Access Compliance Report

Public Rights-of-Way

Intersection ID: 23006	Main Street: GREYCREST_DR	Cross Street: INDIAN_HILLS_LN	Location: SW
ADA ID: D8B48B374F3E	Ramp Type: PerpDiag	Initial Pass/Fail: Fail	Overall Compliance: No
Severity Score: 8.75			
Codes/Mitigation Info/Possible Solution		Field Measurements/Component Compliance

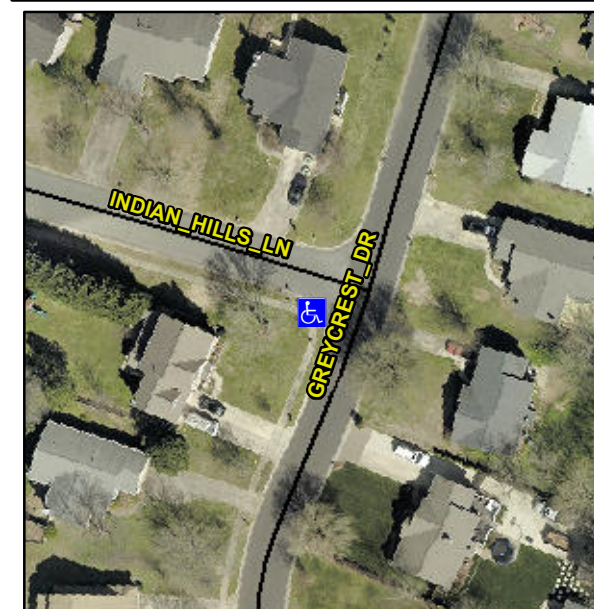
Not Found, R304.5.1

Compliance	Description	Data	Compliance	Description	Data
N/A	Ramp Length (in)	46.0	Yes	Ramp Slope (%)	5.4
No	Ramp Width (in)	36.5	Yes	Ramp XSlope (%)	1.6
N/A	Flare Type LT	N/A	N/A	Flare Type RT	N/A
N/A	Flare Slope LT (%)	N/A	N/A	Flare Slope RT (%)	N/A
N/A	Flare Traversable LT?	N/A	N/A	Flare Traversable RT?	N/A
N/A	Landing Length (in)	N/A	N/A	DWS Provided?	N/A
N/A	Landing Width (in)	N/A	N/A	DWS Contrast?	N/A
N/A	Landing Slope (%)	N/A	N/A	DWS Length (in)	N/A
N/A	Landing X Slope (%)	N/A	N/A	DWS Full Width?	N/A
N/A	Landing Curb? (Y/N)	N/A	N/A	DWS Offset (in)	N/A
N/A	Shared Landing?	N/A			
N/A	Gutter Ponding?	N/A	N/A	Gutter Slope (%)	N/A
N/A	Gutter Lip Ht (in)	N/A	N/A	Gutter X Slope (%)	N/A
N/A	Painted X Walk1?	No	N/A	Painted X Walk2?	No
	X Walk 1 Direction	To NE		X Walk 2 Direction	To SE
N/A	X Walk 1 Width (in)	N/A	N/A	X Walk 2 Width (in)	N/A
	X Walk 1 Slope (%)	0.4		X Walk 2 Slope (%)	1.4
	X Walk 1 X Slope (%)	0.5		X Walk 2 X Slope (%)	3.2

Remove & Replace Curb Ramp With Two New Directional Ramps or Equivalent.
